SERVICE BULLETIN

Model: 4-32 kW

Subject: ADC 2100 Updates

Figure 2 ADC 2100 P7 Jumper Location
Shown with the Back Cover Removed)

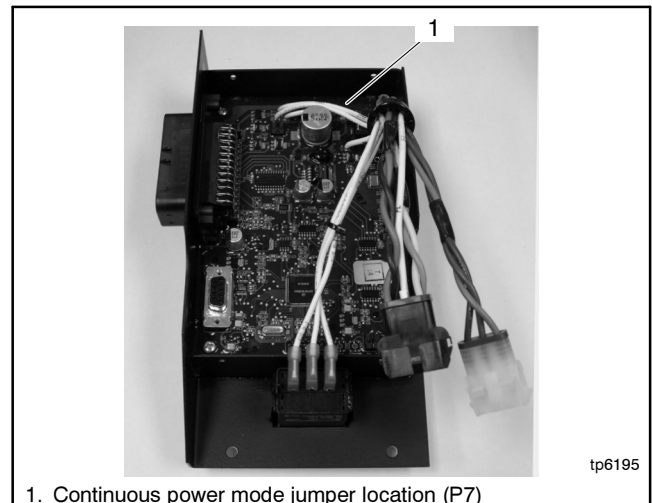
Continuous Power Mode Jumper (P7) Eliminated

The upgraded ADC 2100 is similar in appearance to earlier versions but it does not contain the continuous power mode jumper (P7). See Figure 2 for the P7 jumper location.

This upgrade allows the ADC 2100 to power up when the generator set master switch is moved to the AUTO position. This modification to the ADC 2100 appears on application program version 1.18 or later so that:

- If the ADC 2100 is configured for a CAN gauge (*communications parameter setting Cn01 or Cn02*), the controller will not power down.
- If the ADC 2100 is not configured for a CAN gauge (*communications parameter setting Cn00*), the controller will power down after 48 hours. If the generator set has been started, the controller will power down 48 hours after the generator stops if not restarted.

To determine if a certain unit contains the upgraded ADC 2100 hardware (without the P7 jumper), check the generator set serial number for 2051416 or higher.
